STAFF REPORT

HISTORIC DOWNTOWN ADVISORY COMMISSION

1. CERTIFICATE OF APPROPRIATENESS

Applicant: Victoria Damiani Davis DBA SoHo Luxury Exchange
Location: 32 E Olentangy St
Zoning: DB – Downtown Business District
Request: Review and approval of exterior building and property improvements.

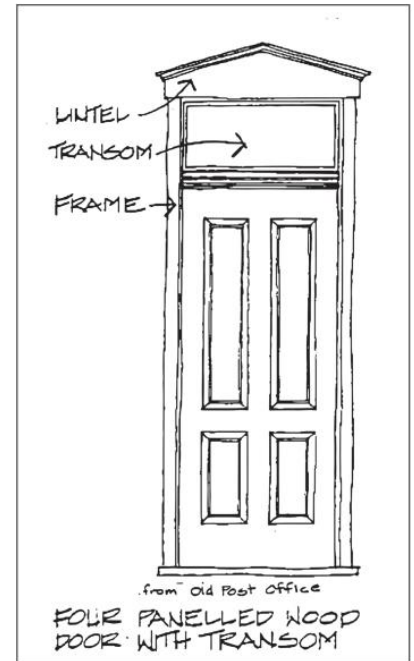
- Proposed Landscaping: Please refer to the Front and Back Landscape Plans and the “Inspirational Photos” page.
 - Staff Comments: The proposed landscaping plan will be an inviting addition to the front yard, and help to activate the site from Olentangy Street. Staff would urge the applicant to reconsider the proposed climbing plant on the west side of the building. If the Commission approves the climbing material, it must be carefully controlled by the applicant as to not damage the building materials per the PAG.
